Site 2 Australia Avenue, Sydney Olympic Park Architectural Design Competition Report

Submitted to Sydney Olympic Park Authority On behalf of Ecove Group

10 September 2018 | 218132

This Architectural Design Competition Report has been reviewed and endorsed by the Competition Jury, which comprises:

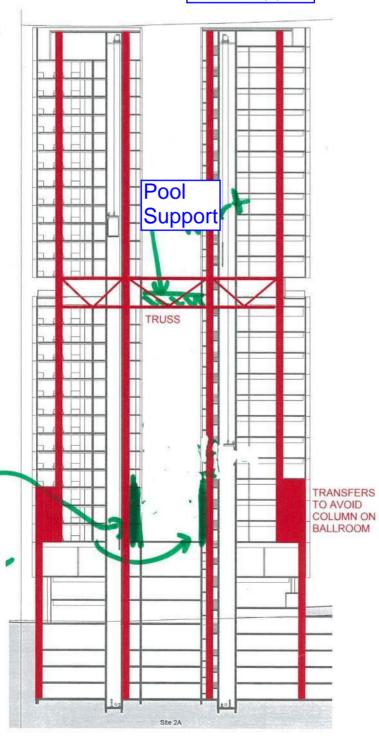
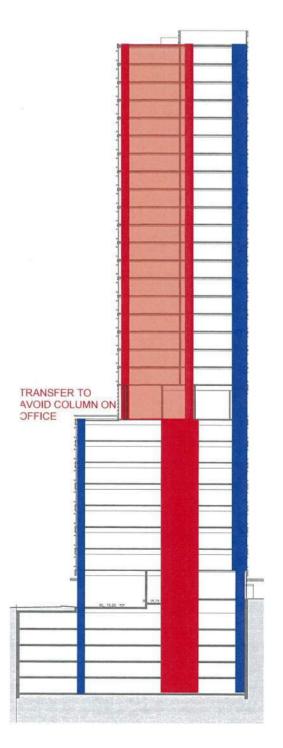
Column transfer beyond over ballroom

# Architecture | Section A

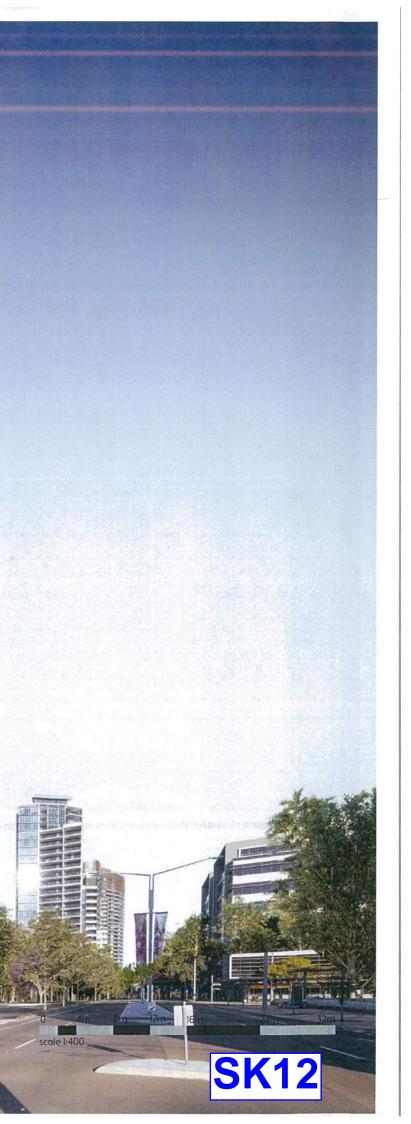
Steel truss framing required

# Architecture | 2A Collaboration Work Floor Plan | 1:200

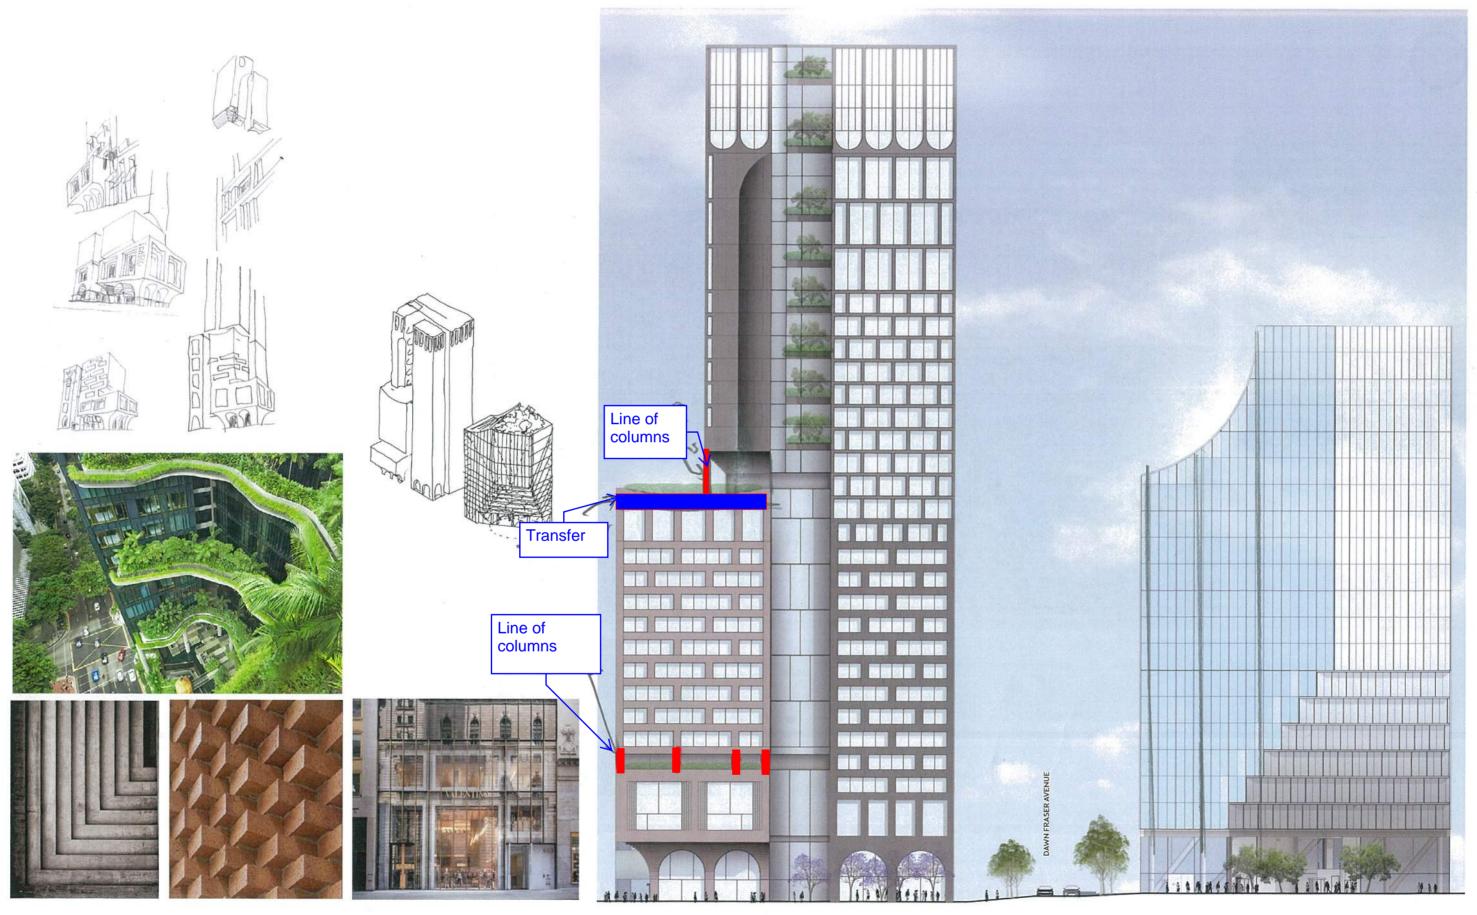
# No resolution of structure through garden terrace (Level 14)
